Technical Service Bulletin

GROUP BODY ELECTRICAL	NUMBER 20-BE-002H-1
DATE MARCH, 2020	MODEL(S) PALISADE (LX2)

SUBJECT: BLIND-SPOT COLLISION WARNING (BCW) RADAR UPDATE

This TSB supersedes TSB# 20-BE-002H to add a note advising technicians to not perform the BCW radar calibration procedure after performing this software update.

ROM ID INFORMATION TABLE:

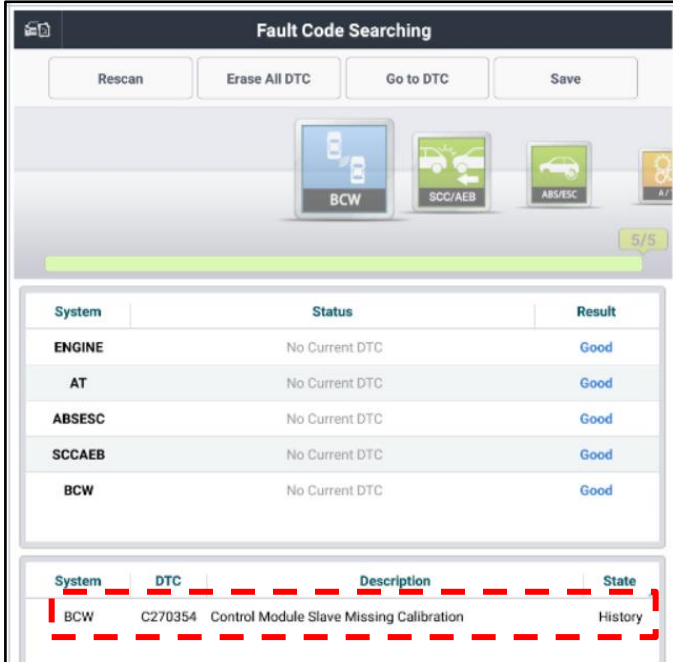
- Check the current version of the BCW ROM ID and compare it to the ROM ID information table listed below before attempting to update the BCW system.

MODEL	BCW P/N	ROM ID	
		OLD	NEW
Palisade (LX2)	99140-S8010 (LHD radar)	LX19_1.01_LX19_1.01	LX19_1.02_LX19_1.02
	99150-S8010 (RHD radar)
